2.5.4 Stability of Subsurface Materials and Foundations

SSAR Section 2.5.4 presents the applicant's evaluation of the stability of subsurface materials that underlie the VEGP ESP site. There are a total of 12 subsections within SSAR Section 2.5.4. Among them, Section 2.5.4.1 does not contain any specific details, but refers to SSAR Sections 2.5.1.1 and 2.5.1.2 regarding regional (within a 320-kilometer (km) (200-mile (mi)) radius) and site area (within an 8-km (5-mi) radius) geology and tectonics for the ESP site. Section 2.5.4.9 cross-references SSAR Sections 2.5.2.6, 2.5.2.7, and 2.5.2.8 for determination of the SSE and operating-basis earthquake (OBE). Section 2.5.4.2 describes the engineering properties of the subsurface materials. Section 2.5.4.3 describes subsurface explorations performed at the ESP site, and Section 2.5.4.4 describes geophysical surveys performed by the applicant to determine shear and compressional wave velocities of the soil and rocks beneath the ESP site. Section 2.5.4.5 describes excavation and backfill work for the ESP site. Section 2.5.4.6 describes local ground water conditions. Section 2.5.4.7 describes site-specific shear wave velocity profile, she

Figure 2.5.4-4 - ESP Site-Specific Base Shear Wave Velocity Profile

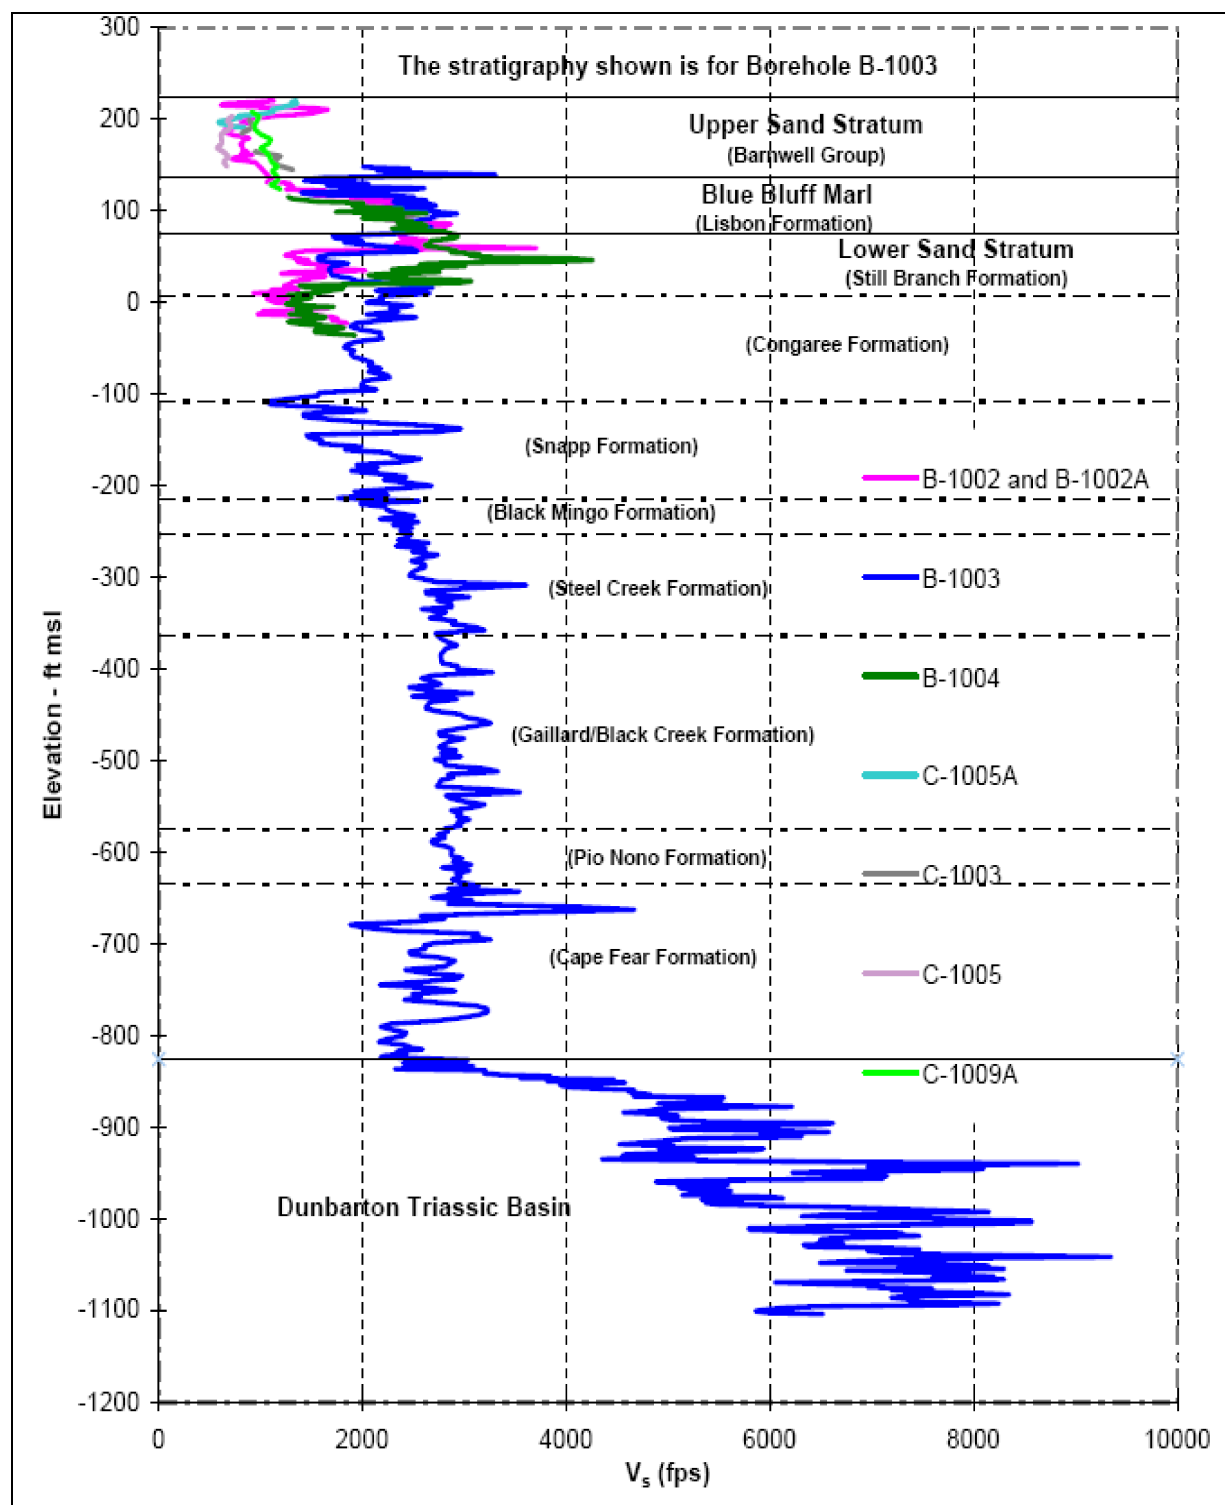
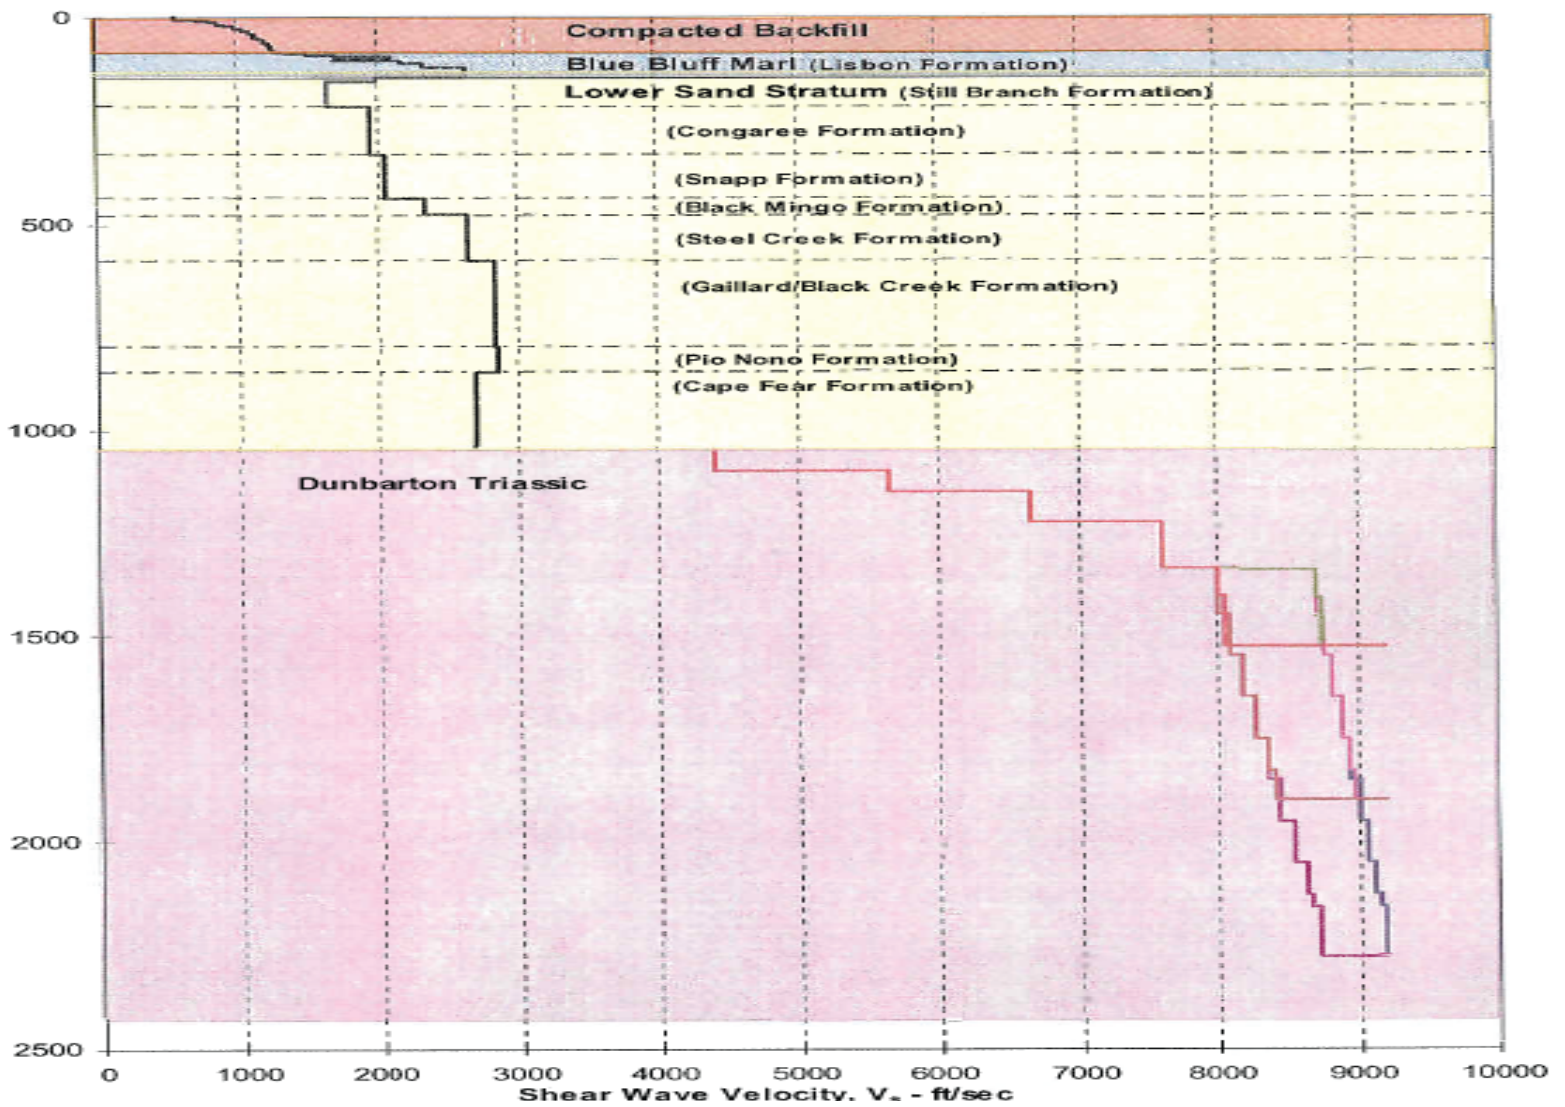
In RAI 2.5.4-3, the staff asked the applicant to explain how it developed the base case shear wave velocity profile based on only 12 borings, since most of them did not go deeper than 91.4 meters (300 ft). In its response to RAI 2.5.4-3, the applicant stated that it developed the base case shear wave velocity profile associated with the Lisbon Formation (Blue Bluff Marl), Still Branch Formation, and the upper portion of the Congaree Formation from the results of the three suspension P-S velocity logging tests performed at the ESP site. One of the suspension P-S velocity logging tests extended into bedrock below the Lower Sand Stratum, and the applicant used those results to derive the base case shear wave velocity profile below the top of the Congaree Formation. The applicant explained that its randomization model, which captures the uncertainty in the base case shear wave velocity profile for the in situ soils, used logarithmic standard deviation of shear wave velocity as a function of depth, which is set to values obtained from soil randomization performed at SRS. After reviewing the applicant's response, the staff, however, finds that shear wave velocities vary significantly among the three profiles (ESP, VEGP, Units 1 and 2 and SRS, most of them terminate at a depth of about 85.34 to 60.96 meters (280 to 300 ft)), shear wave velocities measured from down-hole seismic tests are lower than the suspension P-S velocity measurements. Furthermore, the shear wave velocities from previous investigations were relatively lower than those obtained from the ESP investigations. Therefore, the staff concludes that the applicant did not provide sufficient shear wave velocity measurements to define the site-specific shear wave velocity profile. This is **Open Item 2.5-18**.

2. The applicant provided a site-specific shear wave velocity profile in a situation that the shear wave velocity measured from the down-hole tests were lower than the ones obtained from the suspension P-S velocity measurements; the shear wave velocities from previous investigations associated with VEGP Units 1 and 2 were also lower. Additionally, the applicant did not perform soil dynamic testing on the samples from the ESP site to provide soil modulus reduction and damping curves to feed into the site response study and the site-specific shear wave velocity profile. The shear wave velocity profile and the shear modulus reduction curves, as well as the damping curves, are critical input for the site-specific ground motion spectrum and future SSI.

**Figure 2.5.4-5 - Shear Modulus Reduction Curve For SHAKE2000 Analysis—EPRI Curve
(Reproduced from SSAR Figure 2.5.4-9)**

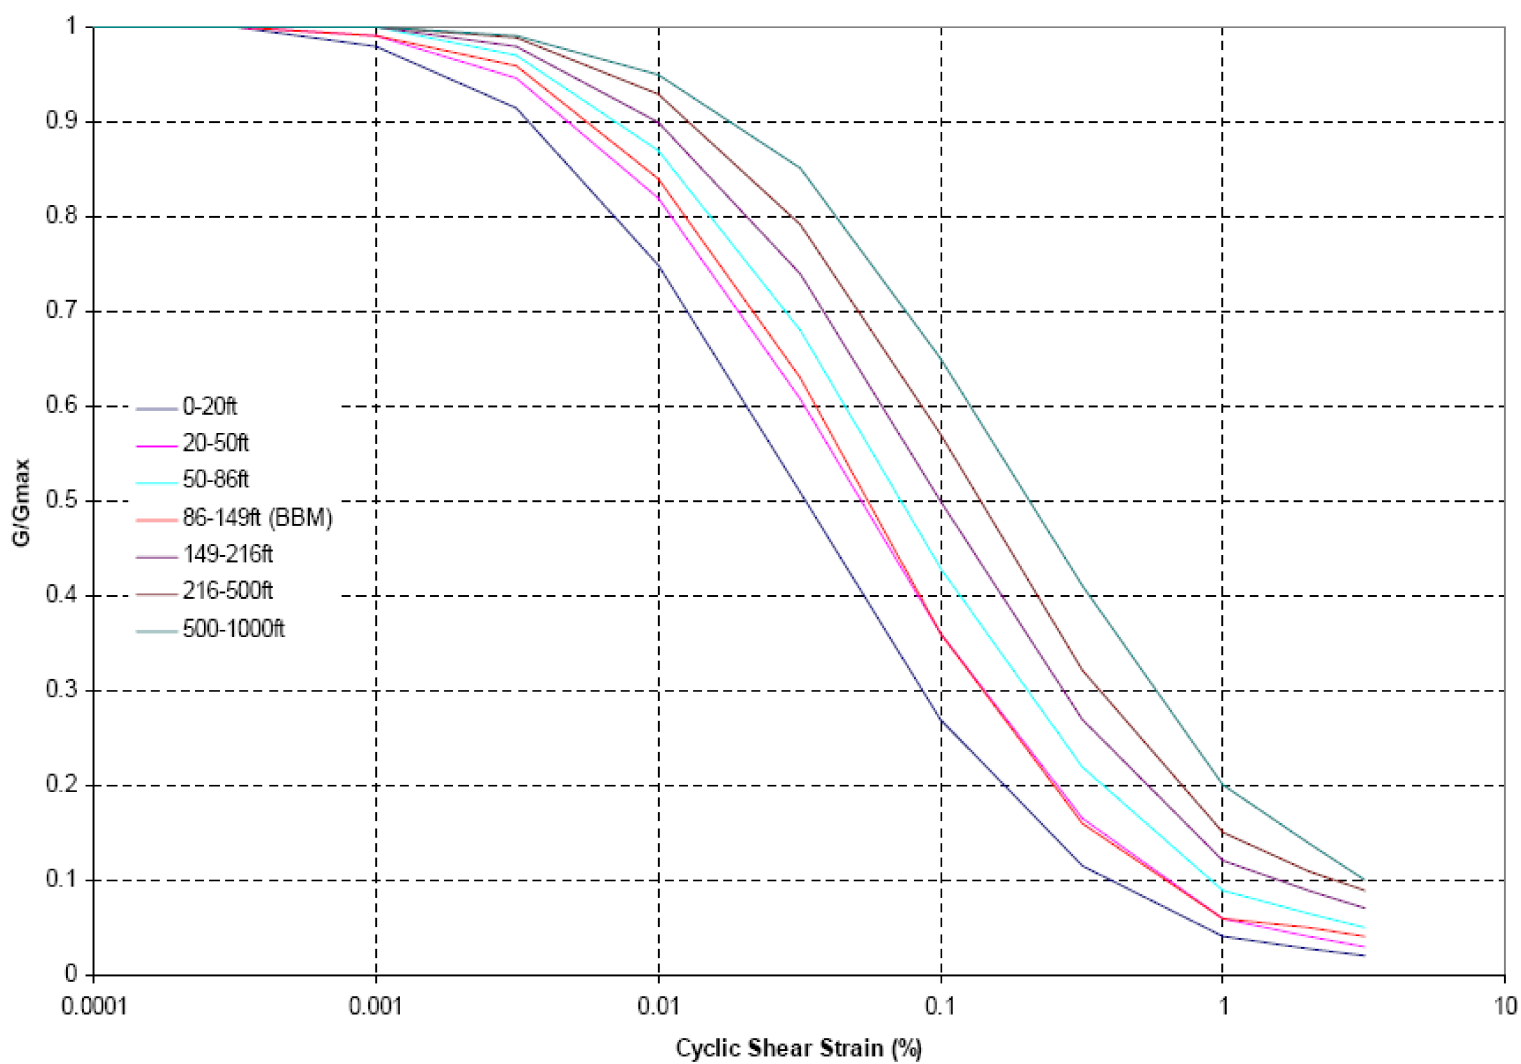
The applicant derived ESP soil shear modulus degradation and damping curves from the curves developed by EPRI (1993). In RAI 2.5.4-5, the staff asked the applicant to justify its application of the EPRI curves to fine-grained soils. In its response, the applicant stated that EPRI (1993) developed degradation curves for soils from gravels to high plasticity clays, and thus it was appropriate to apply the curves to fine-grained soils. EPRI (1993) presented fine-grained soils in Figures 7.A-16 (shear modulus reduction curves) and 7.A-17 (damping ratio curves) in terms of soil plasticity and required the use of the PI. The applicant referred the staff to its response to RAI 2.5.4-17 for more details on how it derived the degradation curves from the EPRI (1993) curves. The applicant further indicated that it would verify the soil degradation relationships for fine-grained soil (and coarse-grained soils) used in the SSAR by laboratory testing during COL subsurface investigation.

After reviewing the applicant's response and its references, the staff finds that Section 7A.6 of the EPRI (1993) report recommends the modulus degradation and hysteretic damping strain-dependent curves for generic CEUS sites. According to the report, these curves are intended for gravelly sands to low plasticity silty or sandy clays and should not be applied to either very gravelly or very clayey deposits. The curves presented in the report for silts and clays of high plasticity are significantly different from those for sandy soils. In its response to RAI 2.5.4-10, however, the applicant indicated that the Blue Bluff Marl "is described as hard, slightly sandy, cemented calcareous clay, and with less than 50% fine material," which is different from the type of materials for which the curves are intended. Therefore, the applicant did not adequately explain why it is appropriate to apply those relationships to the silts and clay soils at the ESP

site. The report further states that, while the generic curves are appropriate for preliminary site studies, one should use site-specific data for final evaluations. In conclusion, the staff concurs with the applicant that it needs to verify the soil modulus degradation and damping curves. However, this verification should not wait until the COL stage. Without site-specific soil modulus degradation and damping curves, the determination of site-specific GMRS (SSE) is inadequate. To provide site-specific soil degradation and damping ratio curves for the site-specific soil amplification calculation discussed in SER Section 2.5.2 is **Open Item 2.5-19**.

Figure 2.5.4-6 - Shear Modulus Reduction Curve for SHAKE2000 Analysis—SRS Curve

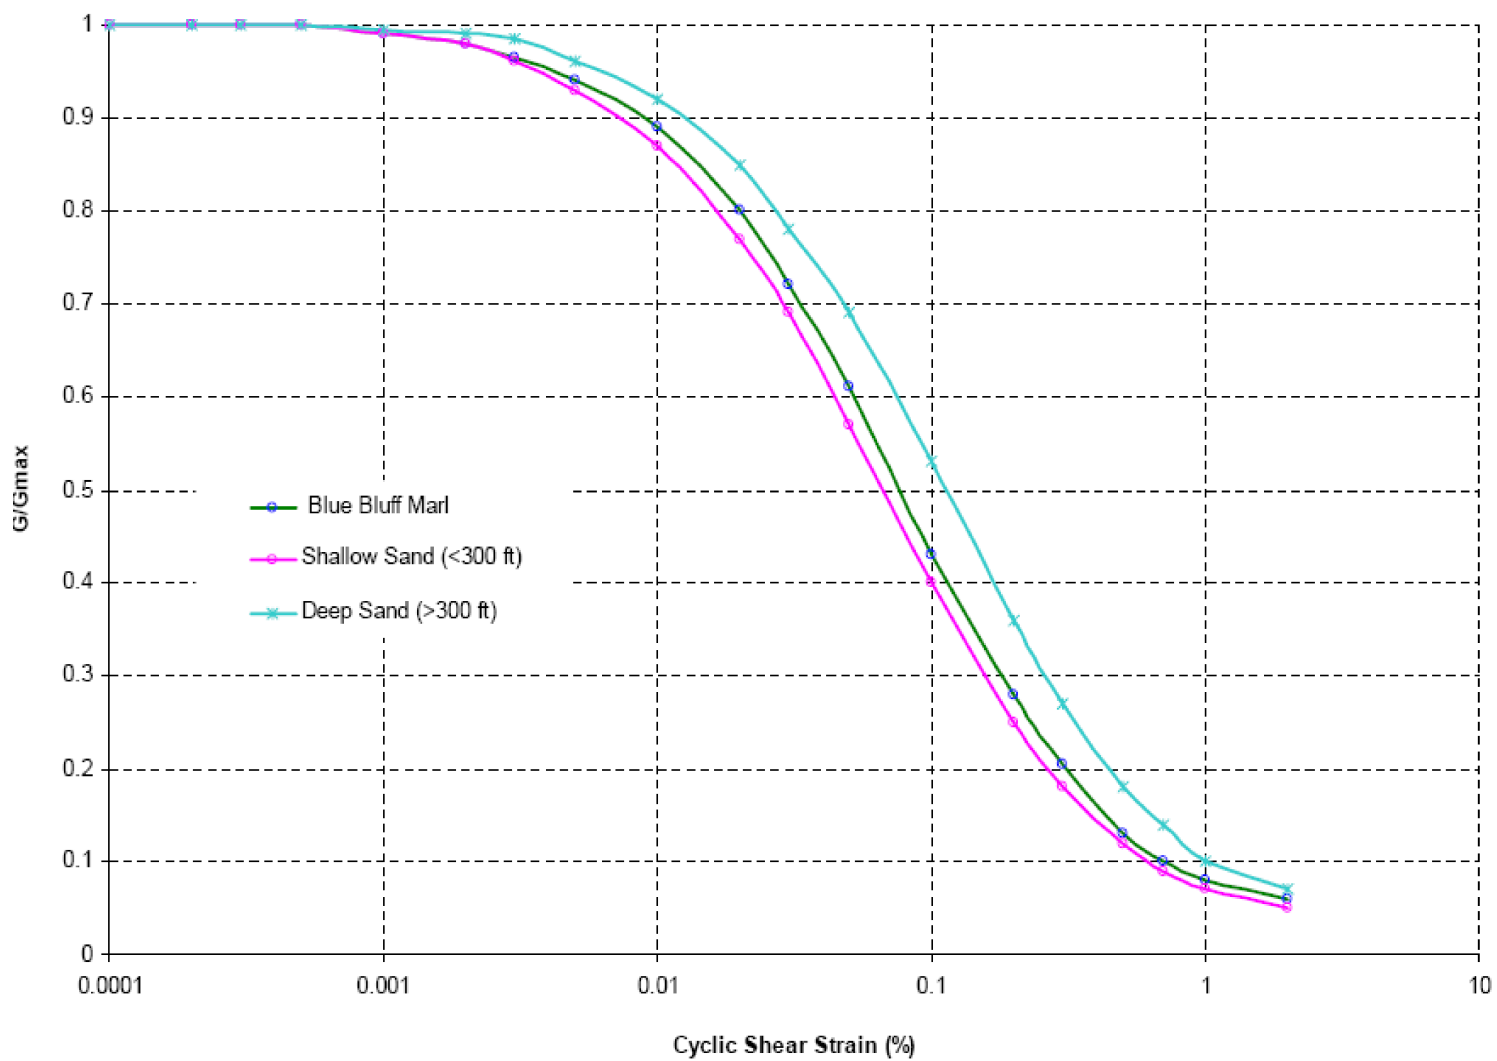
The applicant stated that it followed the EPRI procedures (EPRI TR-102293) to derive the dynamic shear modulus reduction in terms of depth for the granular soils (Upper and Lower Sand Strata) and the plasticity index (PI) for the cohesive soils (Blue Bluff Marl) (see SER Figure 2.5.4-5). The applicant also indicated that it used SRS shear modulus reduction factors, but did not explain how these were used (see SER Figure 2.5.4-6).

**Figure 2.5.4-9 - Allowable Bearing Capacity of Typical Foundations
(Reproduced from SSAR Figure 2.5.4-13)**

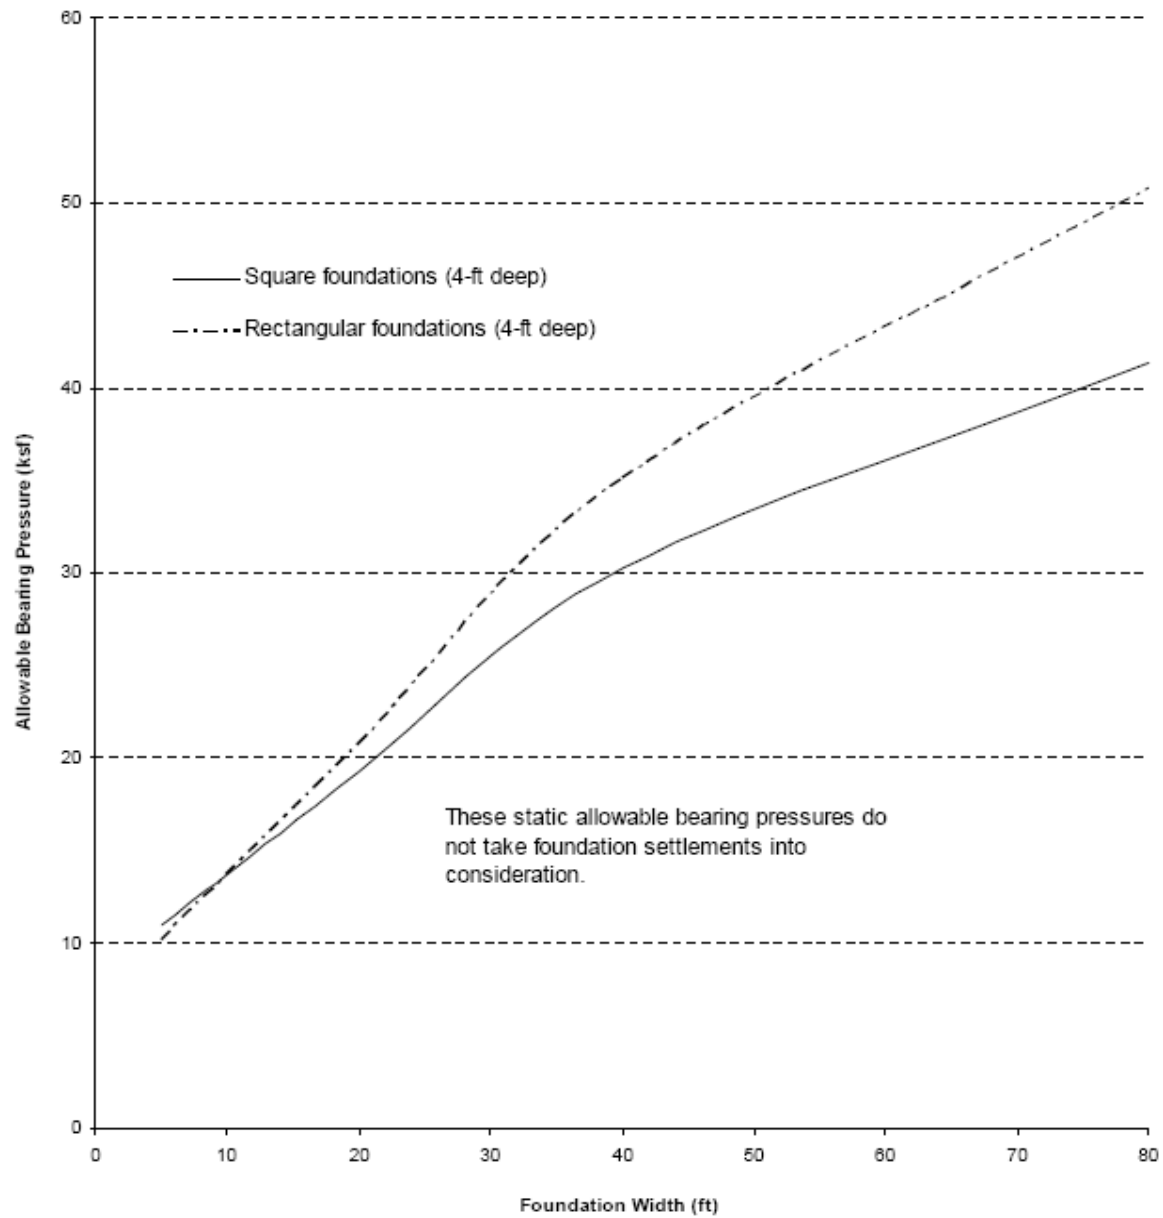
In RAI 2.5.4-18, the staff asked the applicant to provide detailed information on its determination of the allowable bearing capacity value. In its response, the applicant provided a detailed description of bearing capacity evaluations based on the Vesic (1975) formula. In addition, the applicant later clarified that the calculated value was net allowable bearing capacity, not the gross bearing capacity; therefore, the formula used in the actual calculation was slightly different from that presented in the reference. From its review of the applicant's response, the staff considers that the Vesic (1975) formula is based on primary assumptions of gross shear failure of soils under the foundation. Although this allowable bearing capacity formulation is applicable for general foundation analysis, it is inappropriate to use it in nuclear power plant foundation design. The control factors of allowable contact pressure for a large and heavy structure typically are not general shear failure but are (1) settlements; (2) allowable pressures used in design of the wall/basemat intersection; and (3) toe pressures developed during potential overturning and sliding of the facility. Based on the above considerations, the staff concludes that the allowable bearing capacity value provided by the applicant is not appropriate when considering the expected governing issues controlling the site evaluation. This is **Open Item 2.5-22**.

4. The applicant used some general methods in its calculations and analyses without thoroughly examining all important factors and considering all possible scenarios. For example, the applicant used the Vesic (1975) formula to determine the allowable bearing capacity of the bearing stratum. Since the formulation was based on primary assumptions of gross shear failure of soils under the foundation, it is applicable for general foundation analysis, but not appropriate for use in nuclear power plant foundation design because the typical control factors of the allowable contact pressure for such large and heavy structures are settlements, allowable pressures that are used in the design of the wall/basemat intersection, and toe pressures developed during potential overturning and sliding of the facility.
